Proposal for amendments to ECE/TRANS/WP.29/GRRF/2014/10 (Regulation No. 13-H splitting)

This document supersedes document ECE/TRANS/GRRF/2014/10. The changes to the current text of the regulation are marked in **bold** and ~~strike through~~ characters.

Approval mark and Paragraph of Model A, amend to read:

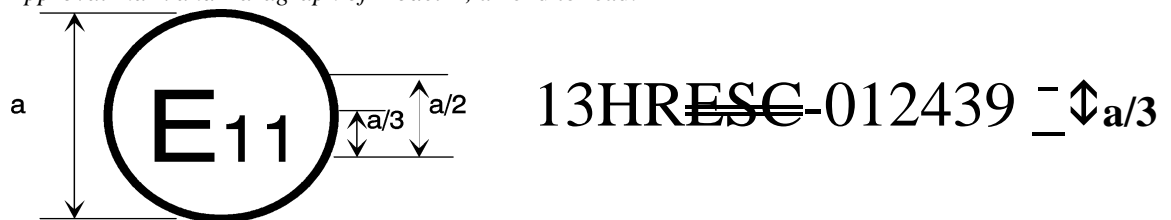
The above approval mark affixed to a vehicle shows that the vehicle type concerned has, with regard to braking, been approved in the United Kingdom (E11) pursuant to Regulation No. 13-H under approval number 012439. The first two digits of the approval number indicate that the approval was granted in accordance with the requirements of Regulation No. 13-H in its ~~original~~ **01 Series of amendments**. ~~The additional marking "ESC" indicates that the vehicle meets the Electronic Stability Control and Brake Assist System requirements of Annex 9 to this Regulation.~~ **The additional marking "ESC" indicates that the vehicle meets the Electronic Stability Control and Brake Assist System requirements of Annex 9 to this Regulation.**

6. The example of the approval mark in Annex 2 should not contain any reference to ESC and should refer to the 01 Series of amendments.
